KARACHI MUNICIPAL CORPORATION.

Review Form

Case No. P/ 425/40

Re:—plot No. 91 & 92 Sheet No. K2 Lyari Qr:

LYAREE QR
SHEET NO K-2

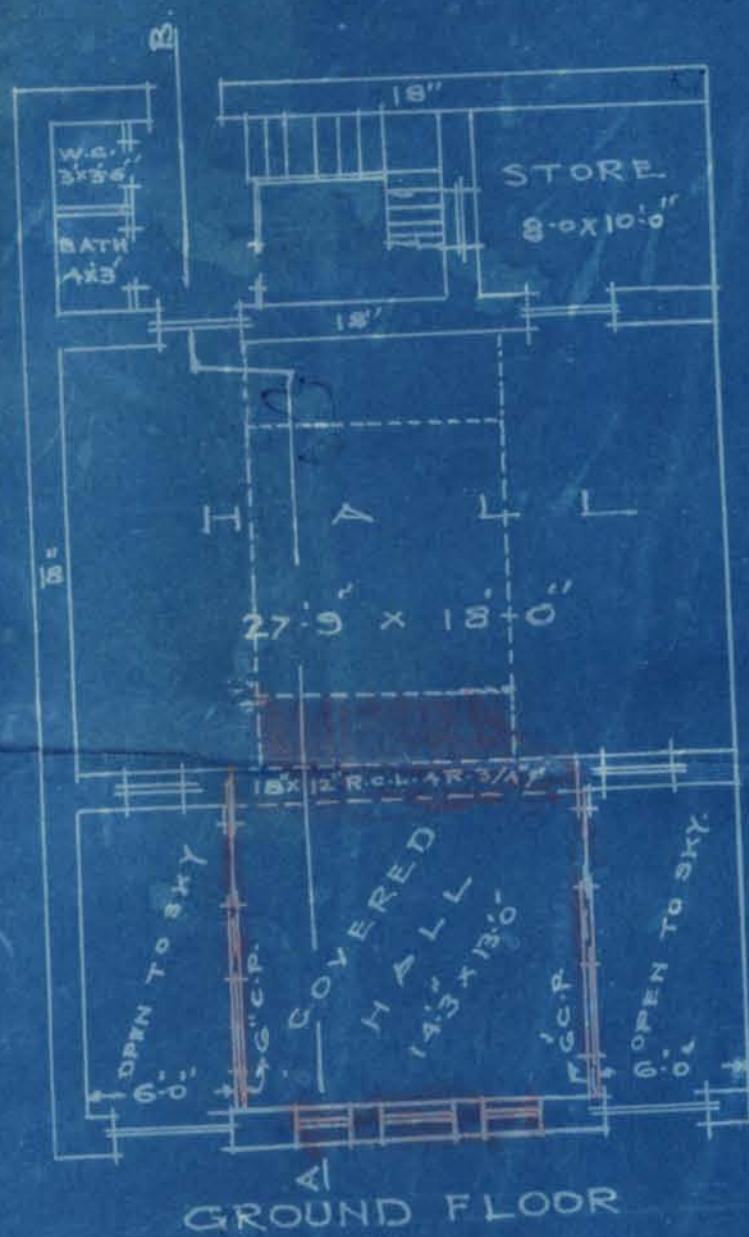
1. Alignment line shown. 2. Correct area to give.
3. Adj. plot nos. to give. 4. Street width to give
5. Correct side measurements to give
6. Plots require amalgamation. if need

- (1) As desired, the alignment line has been duly shown.
- (2) The area has been duly corrected.
- (3) The adjoining plots Nos. have been duly given, as desired.
- (4) The Street width has also been duly given.
- (5) The site measurements have been duly corrected.
- (6) As will be seen from the accompanying copy of the certified sketch, the plots are already amalgamated.

PLAN SHOWING PROPOSED
ADDITION TO THE EXISTING LECTURE HALL
ON PLOT NO. 91 & 92 SHEET NO. K. 2.
LYAREE QUARTER.

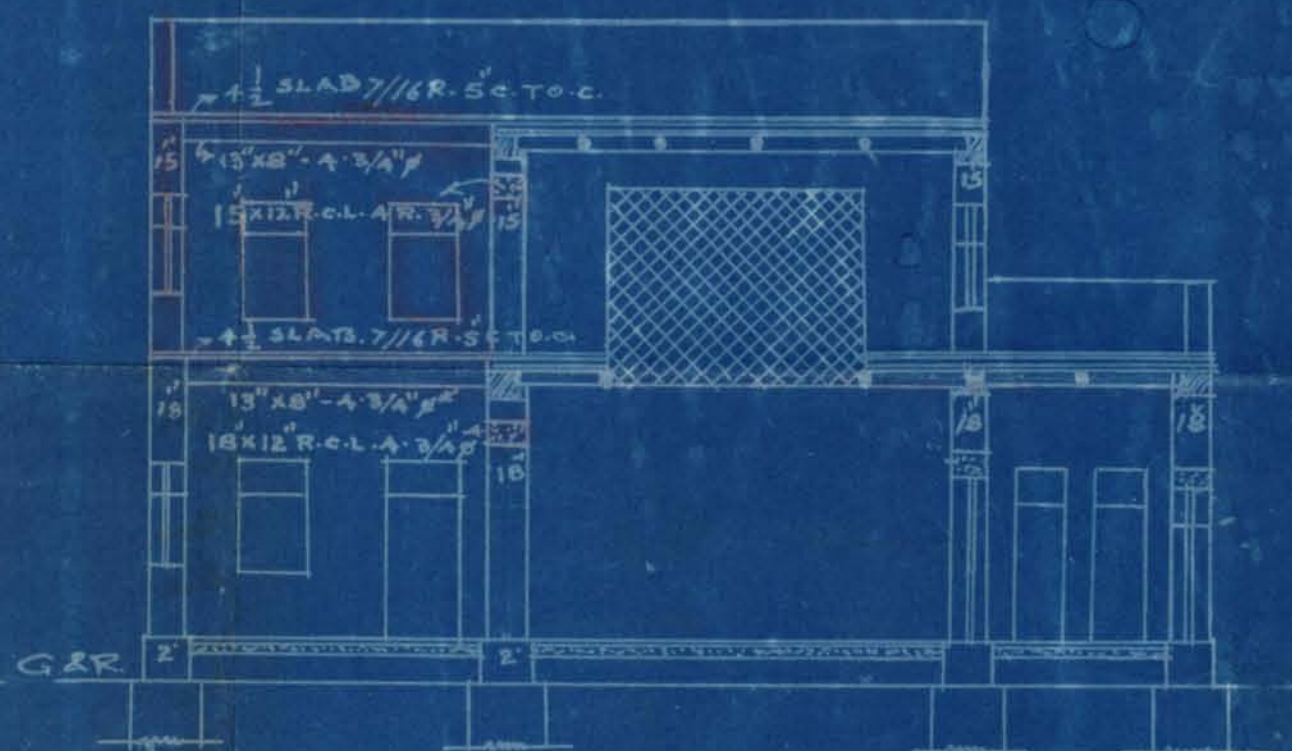
- (1) Alignment line be shown. (2) Correct area be given.
- (3) Adjoining plot Nos. be given. (4) Street width be given (5) correct site measurements be given.
- (6) Plots require amalgamation.

- (7) Authority to sign the plans be produced.
- (8) Plots must be got amalgamated first before the plans for additions and alterations can be considered.
- (9) Correct site plan and also clear nature of proposed structures with those existing be given.

(8) As already stated in No. 6 above, the plots are already amalgamated, which can be seen from the accompanying copy of the certified sketch.

(9) The site plan has been duly corrected and the proposed work has been clearly shown in red.
